TI APERTURE CARD  
 NINE MILE POINT NUCLEAR STATION-UNIT 2  
 NIAGARA MOHAWK POWER CORPORATION  
 J.O. NO. 12177 - P.O. NO. NMP2-P223E

NO. UNITS REQD.	ONE / PT #	CUST. DWG. OR SPEC.
CUSTOMER ORDER NO.	NMP2-P223E	CUST. TAG OR ITEM NO. ZEGF-TK 1,1B,2
<b>RICHMOND ENGINEERING CO., INC.</b>		
RICHMOND VIRGINIA		
MISCELLANEOUS DETAILS		
NIAGARA MOHAWK / STONE & WEBSTER		
JOB NO.	DATE	DRAWN BY
N-2443	4-24-78	J. HARRIS
CHECKED BY	APPROVED	DRAWING NO.
BT		0-78-158 12
30,40,50

NOZZLES M1,2 #3 WITH SPOOL PIECES

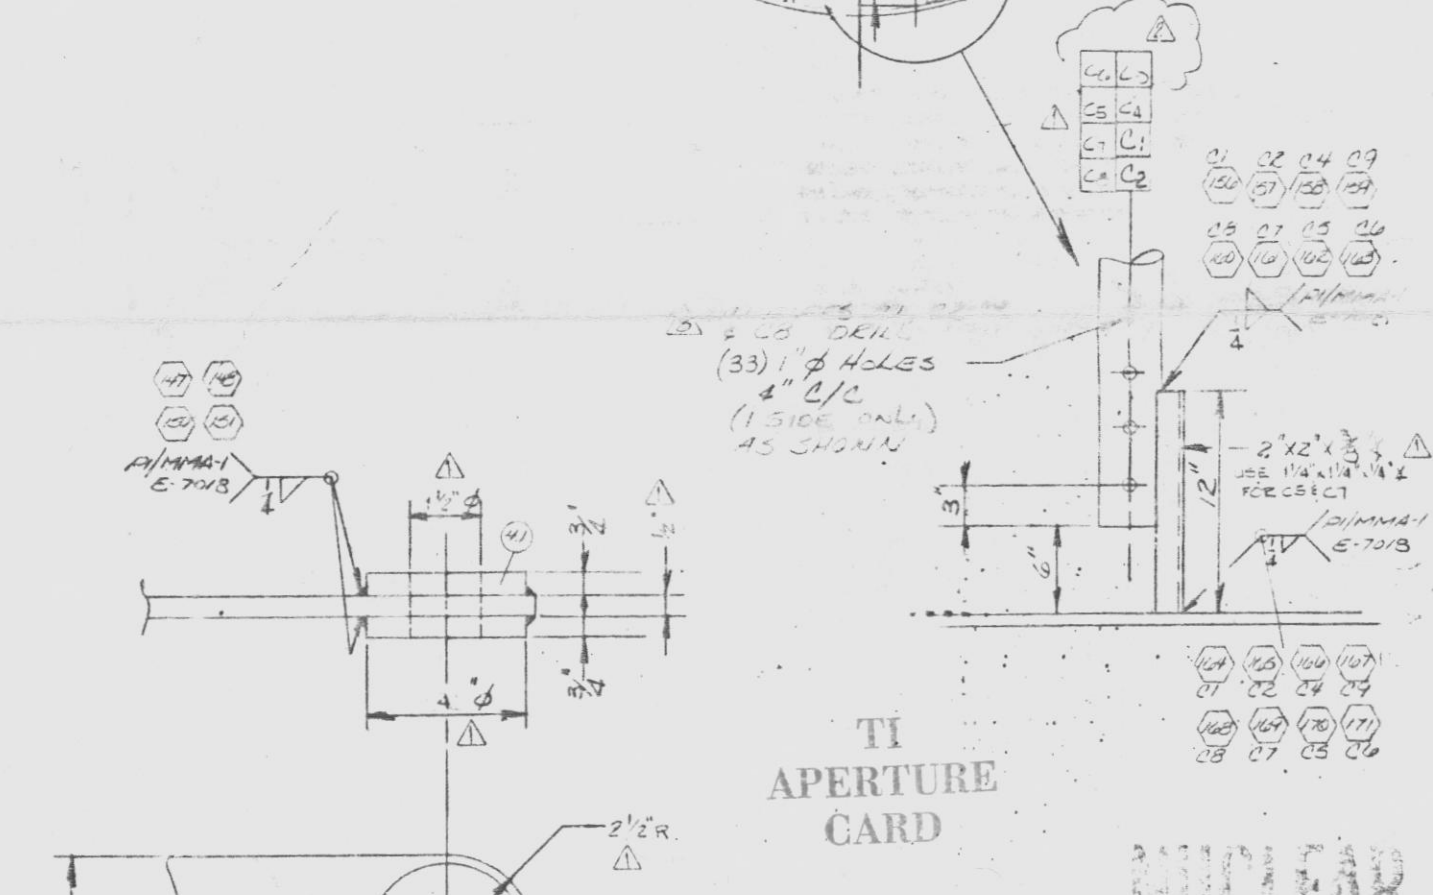
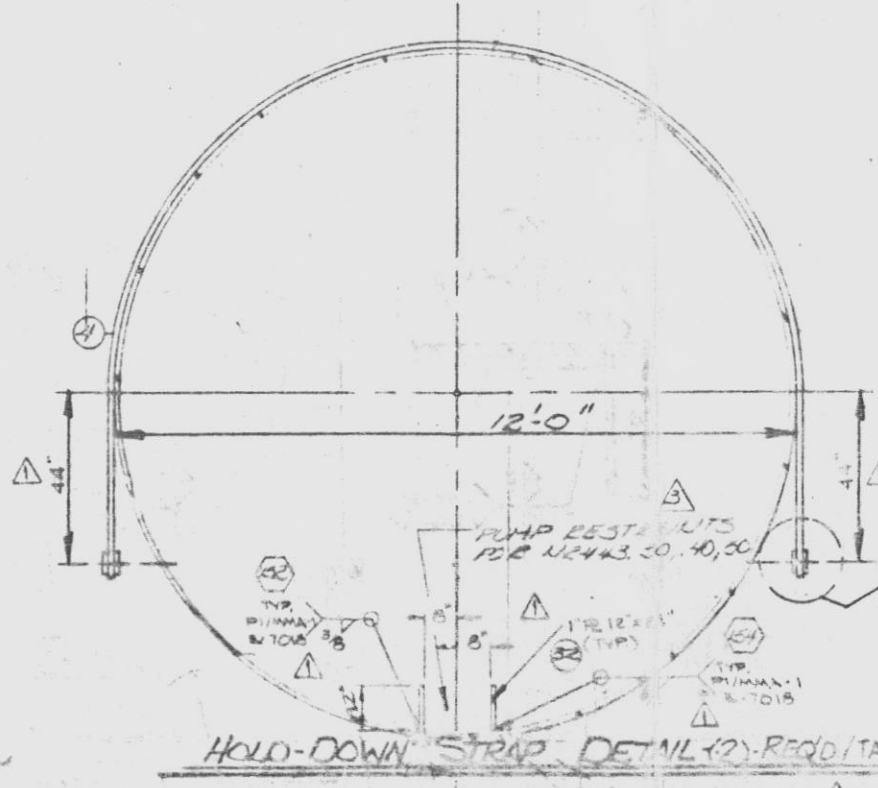
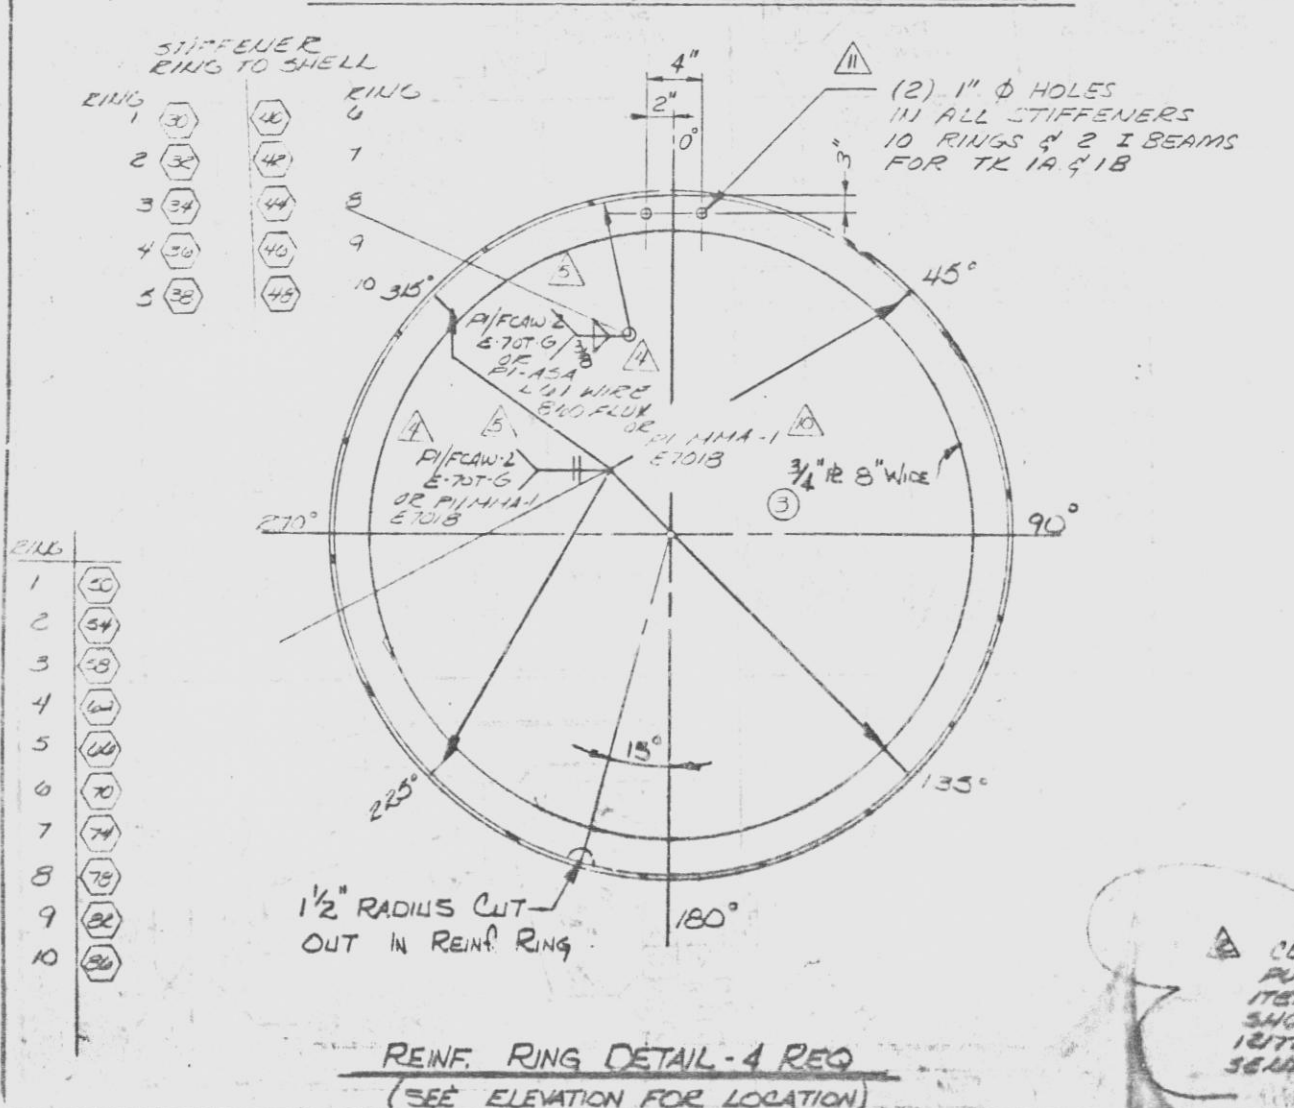
REV. NO.	CHANGE NOTICE	DESCRIPTION	BY	DATE	ENG. I.D.
1		ADDED DETAIL A	WEG	7/26/82	WJG
2		REVISIONS
